Biloxi Marsh Lands Corporation
Lake Eugenie Land & Development, Inc.

RE: Comments
DRAFT 2017 Coastal Master Plan

A review of subsidence in the vicinity of The Biloxi Marsh Lands Property in St. Bernard Parish Louisiana

**Restoration and Sustainability of the Biloxi Marsh Complex:
Comments on the 2017 Comprehensive Master Plan**

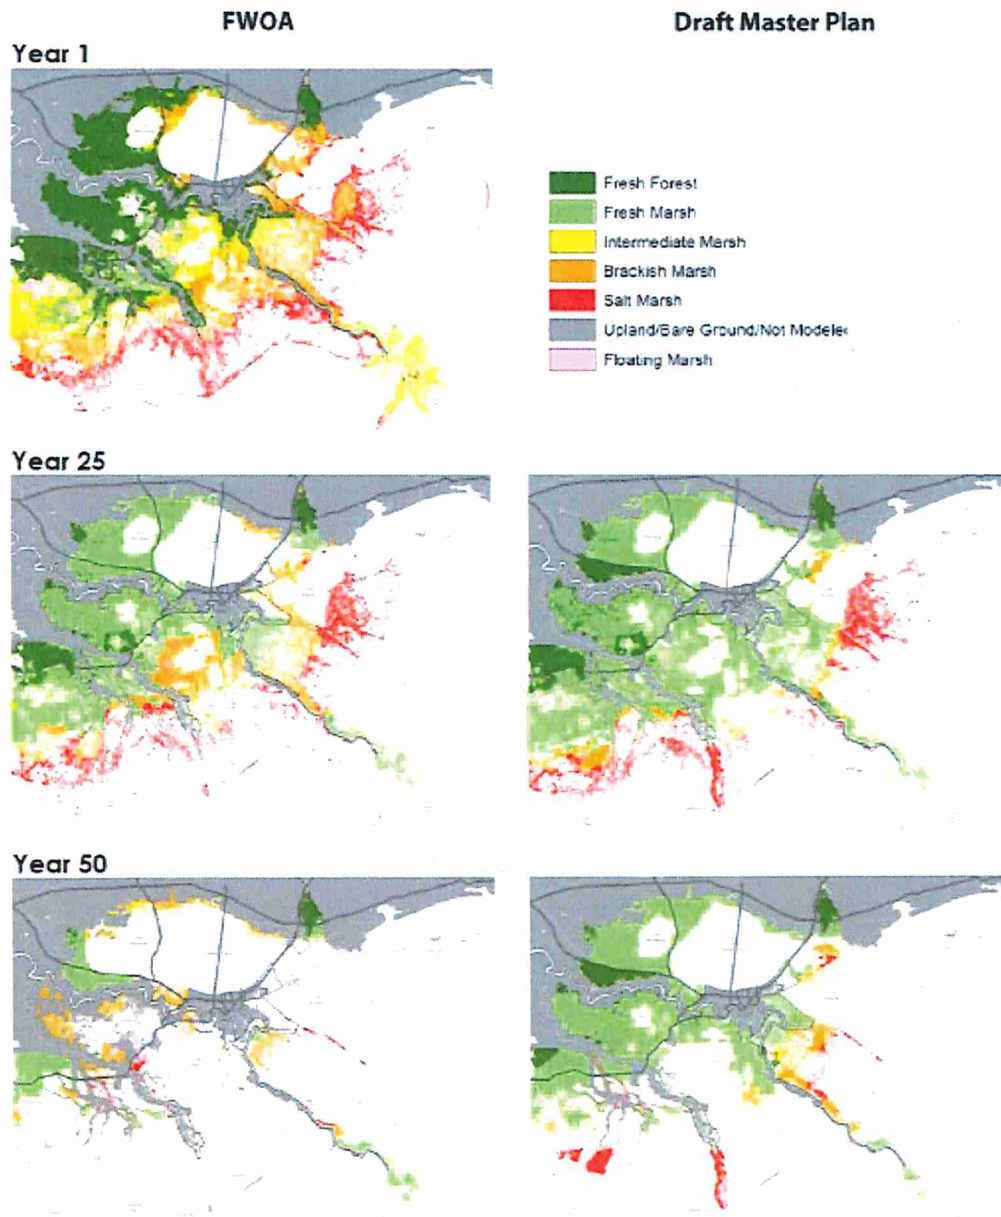
CMP17 provides a sobering view of what the future holds for all of Louisiana's coastal wetlands (Figure 1). Despite a projected expenditure of \$25B on restoration projects over 50 years in addition to another \$25B on levee and floodwall construction, land loss in the CMP Eastern Region that includes BMC property is slowed only by 16 and 24 percent for the Medium and High sea level rise rates (SLR, Table 1), respectively, when compared to the Future Without Action (FWOA).

Another apparent model artifact that needs more investigation is the unrealistic persistence and spread of relatively fragile fresh marsh in the model output. The CMP17 notes that “fresh marsh is not subjected to an inundation collapse criterion; therefore, regardless of the sea level rise and subsidence rates modeled, fresh marsh did not collapse into open water areas” (p. 237, 2017 CPRA Plan, App. C, Chapter 4). So, unless salinity gets high enough to convert fresh marsh to intermediate or brackish marsh, which *are* subject to inundation collapse, fresh marsh tends to dominate what limited wetlands remain after 50 years in model projections (Figure 1).

Figure 2. Forecast land loss in the BMC by decades under three Eustatic Sea Level Rise (ESLR) scenarios modeled. Project depicted is the Biloxi Marsh Oyster Reef. Remaining marsh in the BMC is similar in Year 50, Year 40 and Year 30 for the Low, Medium and High ESLR scenarios, respectively.

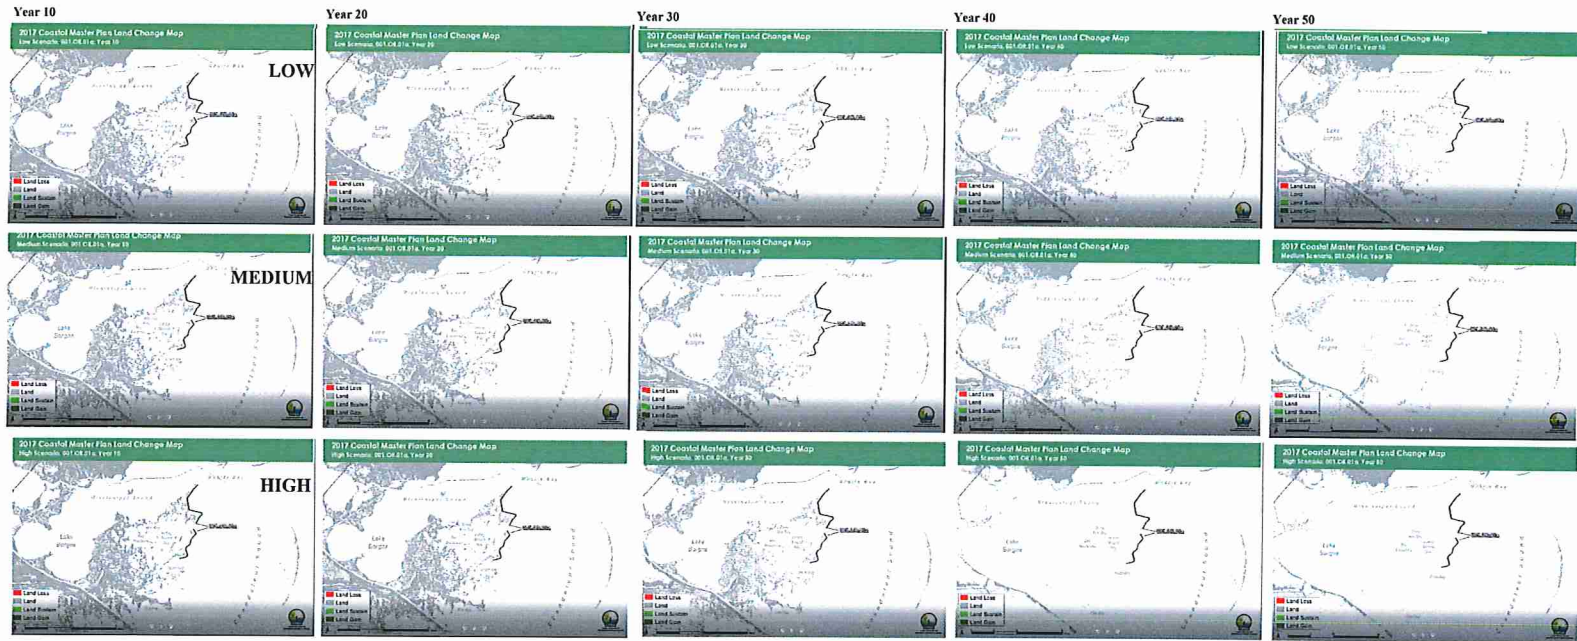
At the end of 50 years during which all proposed CMP17 projects have been constructed and operated as proposed, cumulative land loss is projected to total 2352 and 3775 km² for the Medium and High SLR scenarios, respectively (Table 1), out of an initial 8927 km² of marsh in the Eastern Region in Year 0. Very little brackish or saline marsh remains anywhere in the Eastern Region (Figure 1). The BMC survives beyond 50 years under the Low SLR scenario, but disappears between 40 and 50 years for the Medium SLR, and between 30 and 40 years in the High SLR projection (Figure 2).

Also, we are not convinced that the ICM is really capable of simulating long-term response of shorelines to armoring with rock berms, or protection by natural or artificial oyster reefs and other linear structures (Figure 2). CMP17 authors state with regard to bank stabilization and shoreline protection that “the overall lack of project effects observed is likely in part due to the spatial resolution of the model” (p. 201, 2017 CPRA Plan, App. C, Chapter 4). CMP17 does not include stand-alone shoreline protection or armoring projects, because they produced no change in land gained or lost when modeled ICM.

Figure 4. ICM forecasts that marsh loss and habitat changes for the Eastern Region occur in steps. (Figure 312 from the 2017 CPRA Plan, App. C, Chapter 4)

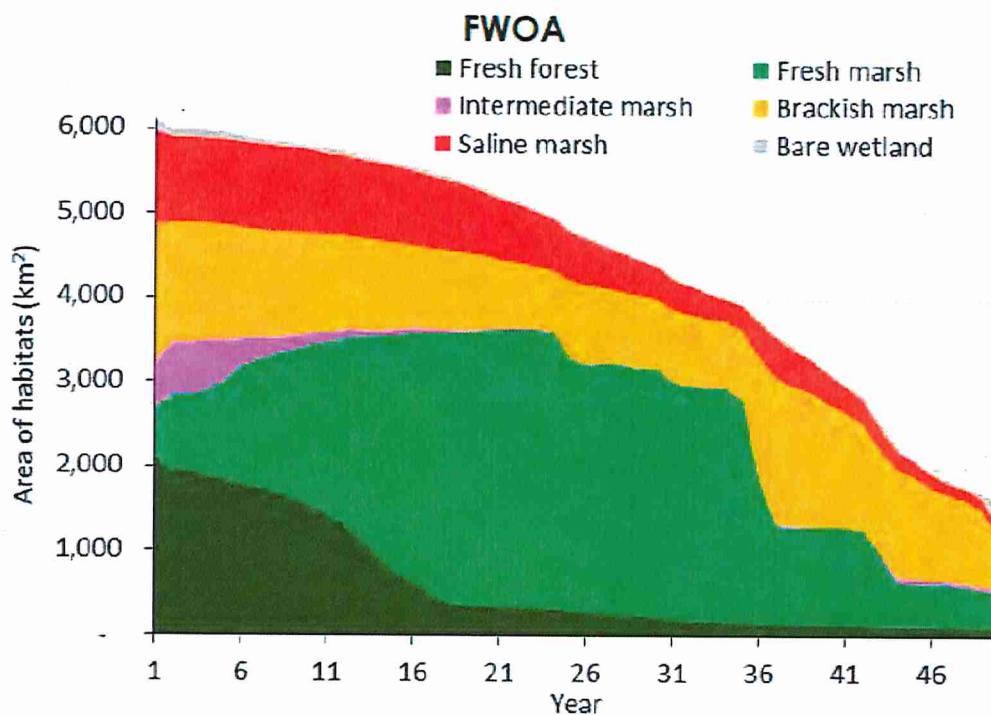
Second, the primary modeled pathway for land loss in CMP17 is triggered by what is termed “marsh collapse,” which occurs when the land surface is predicted to fall below a critical elevation in the tidal frame. Low marshes with a soil surface elevation below this threshold are flooded more frequently and for longer periods than the physiology of marsh vegetation can withstand. The reason that collapse occurs is that sediment input and organic matter production in the root zone is insufficient for the marsh surface to aggrade rapidly enough to keep up with relative sea level rise (RSLR), which is the sum of ESLR and local subsidence. When the marsh vegetation dies, the roots that hold the soil together and give it strength decompose rapidly and the surface drops by 10 cm or more (Nyman et al. 1995, Day et al. 2011). Because of the spatial scale of Integrated Compartment Model (ICM) polygons, when salinity rises or falls, large swaths of wetlands can change to open water or to a new habitat type within a year or two, creating steps in the land-loss/habitat change curves (Figure 4).

Figure 7. Pt. aux Marchettes CWPPRA project ranked highest of all on the 27th Priority Project List includes both rock revetment on the Lake Borgne shore and marsh terracing of BMC interior lakes.

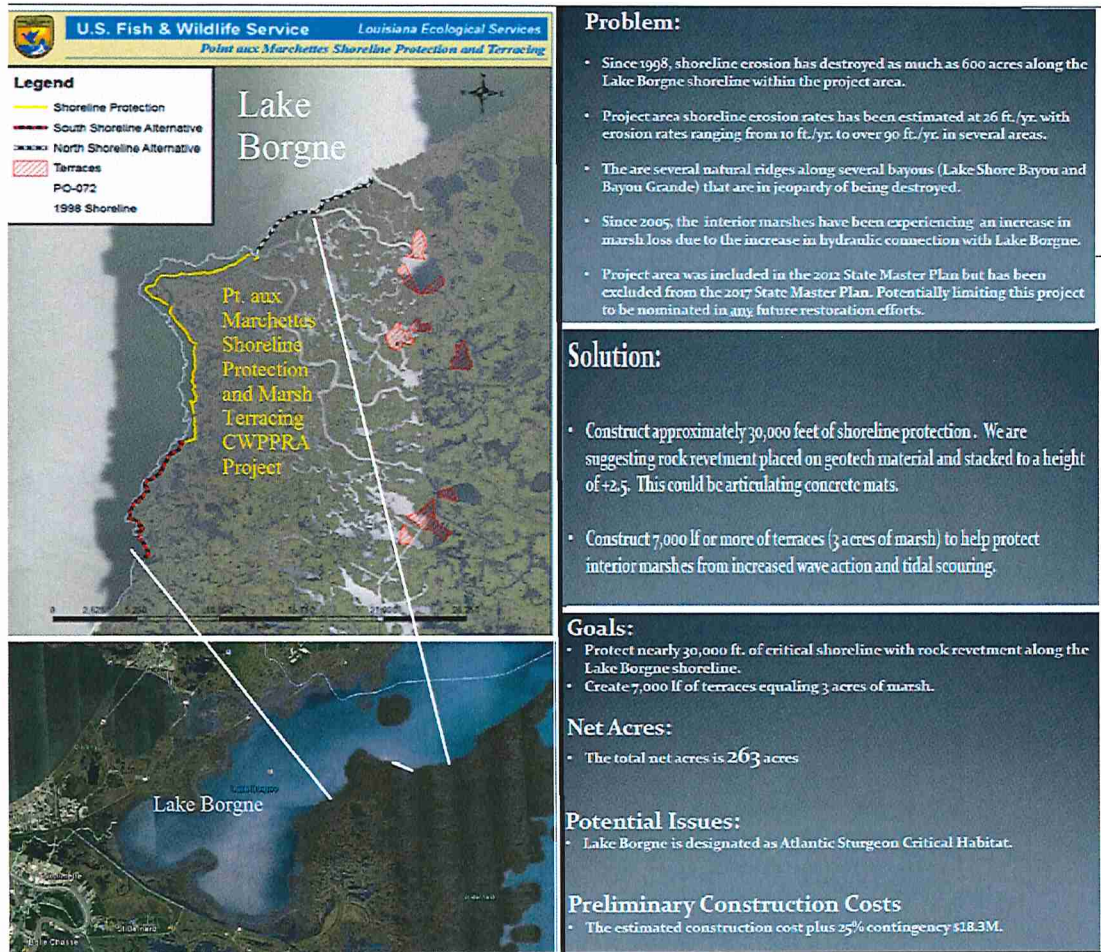
short-term. But in order to be included in CMP17, given the apparent limitations of the ICM, we recommend that such projects be combined with a marsh creation component.

Figure 32. All potential restoration measures proposed in USACE MRGO Ecosystem Restoration Plan for the Biloxi marshes (left), and those accepted (Plan C; right).

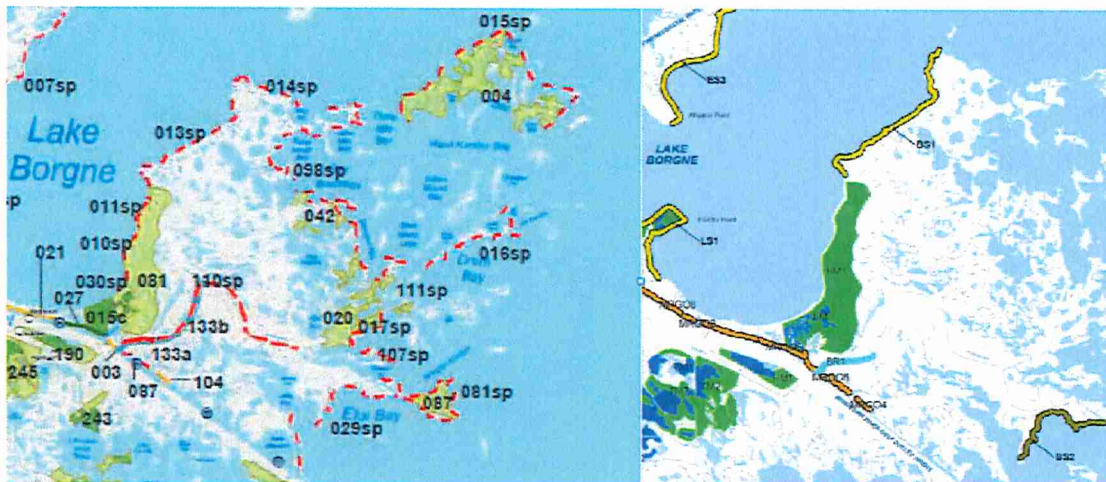
- CMP17 should be consistent with the USACE's MRGO Ecosystem Restoration Alternative Plan C as a continuation of the restoration initiative that caused the deauthorization and closure of the MRGO. Simply damming the MRGO below Bayou LaLoutre without any further ecosystem restoration was never contemplated and is insufficient to preserve the valuable resource which is the BMC,

Four restoration plans ranging were developed by the USACE, ranging from no action (Plan A) to a Plan D that included all feasible restoration measures (Figure 32). Plan C is the Federally Identified Plan (FIP) determined by evaluating a large number of criteria. It called for the most ambitious marsh restoration project ever considered before 2012, apart from that of CMP12. It called for restoring and protecting more than 57,000 acres of habitat, including 10,000 acres of cypress swamp, 14,000 acres of fresh and intermediate marsh, 33,000 acres of brackish marsh, 500 acres of saline marsh, and 54 acres of ridge habitat. Approximately 9,000 acres of restoration features would be located in the BMC, which is not surprising because the BMC has been identified in many plans as a critical landscape feature with respect to storm surge. Interestingly, Plan C differs from CMP17 in including 71 miles of shoreline protection (including 5.8 miles of artificial oyster reef). Additionally, the cypress swamp and forested ridge restoration elements were included, in part, because they were identified as having storm surge damage risk reduction benefits (Figure 33). *The USACE team clearly understood that installing the Rock Dam to close the MRGO is not a substitute for a full restoration program, and is clearly inadequate for protecting, restoring, and sustaining the Biloxi Marsh Complex.*
